DESIGN ADVISORY BOARD

DESIGN ADVISORY BOARD Tuesday November 9, 2021 3:00 PM

To: The Design Advisory Board
From: Mary O'Neil, AICP, Principal Planner
RE: ZP21-509 72-76 Elmwood Avenue
Date: September 28, 2021

To: The Design Advisory Board
From: Ryan Morrison, Associate Planner
RE: ZP-21-732, 278 Main Street
Date: November 9, 2021

**CONCEPTUAL
SITE PLAN**

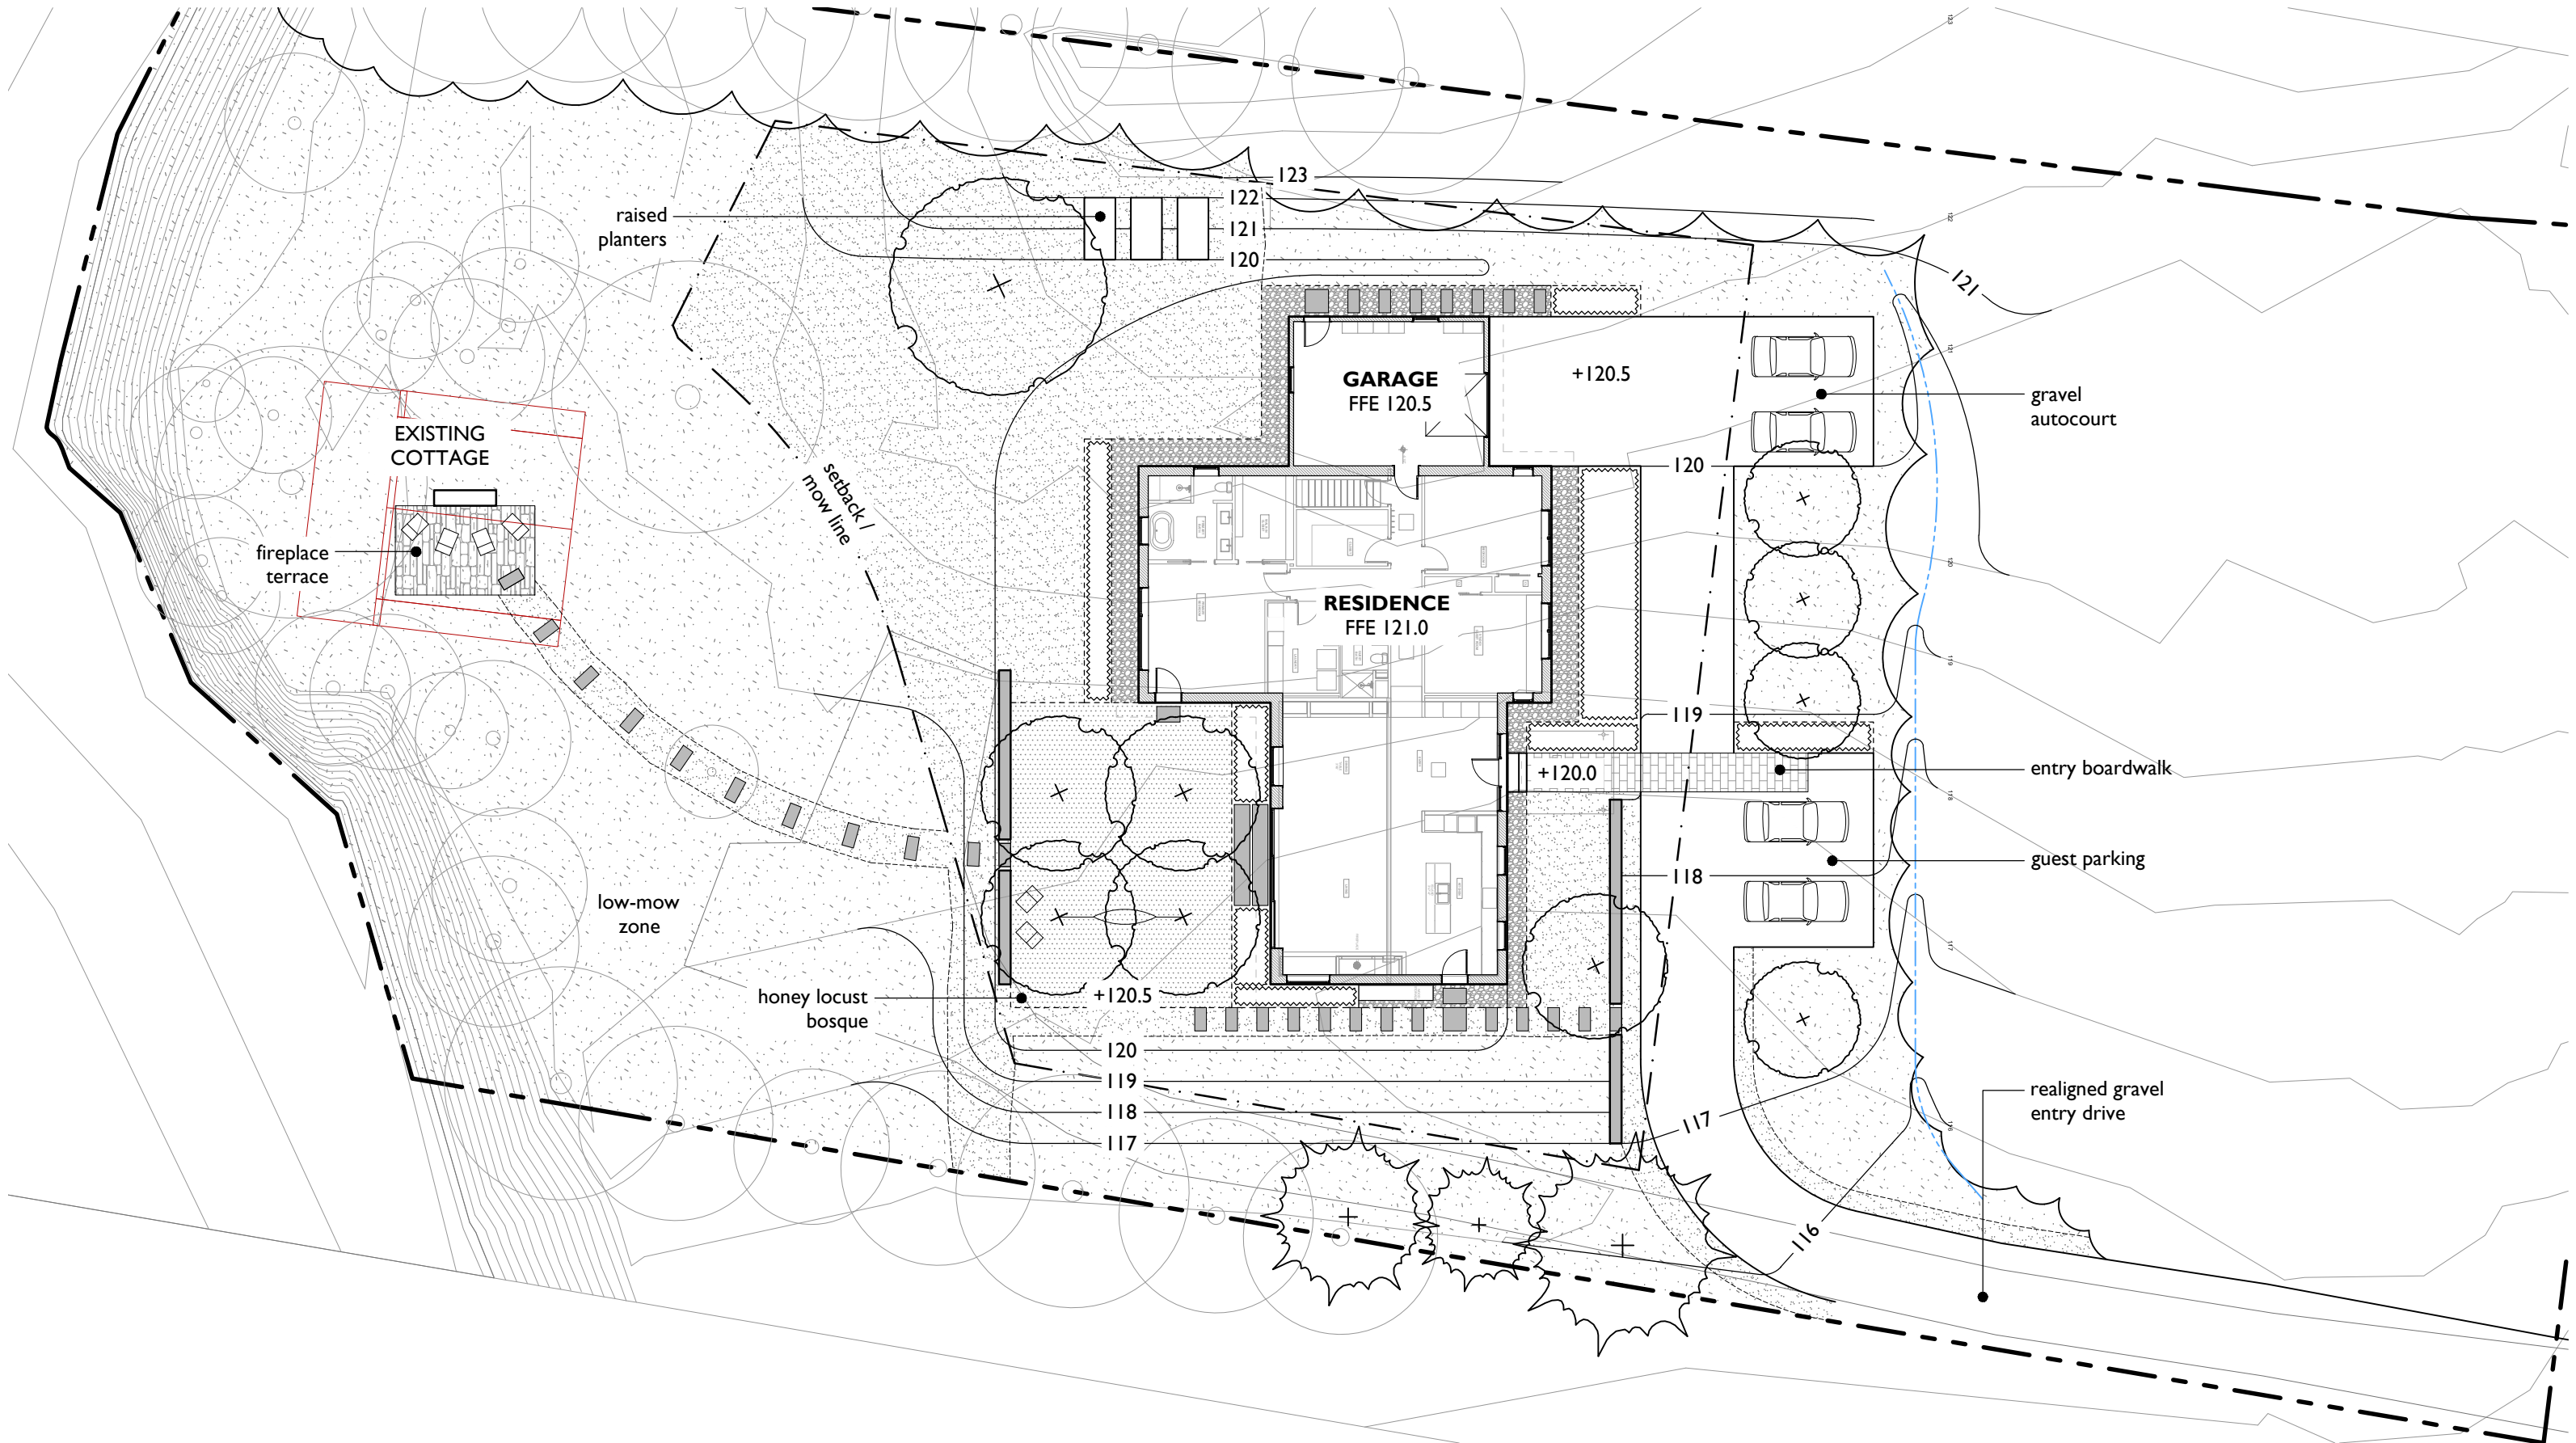
Much of the lakeshore is vegetated, and only limited tree clearing is proposed. A basic landscaping plan has been provided and depicts several new trees to be planted in the green space around the home. Several low landscaping walls are depicted in the project plans, but none appear to function as retaining walls.

Utility lines must be buried as part of this reconstruction. The site plan depicts overhead lines and a relocated utility pole. Relocation of the pole may be moot in light of the undergrounding
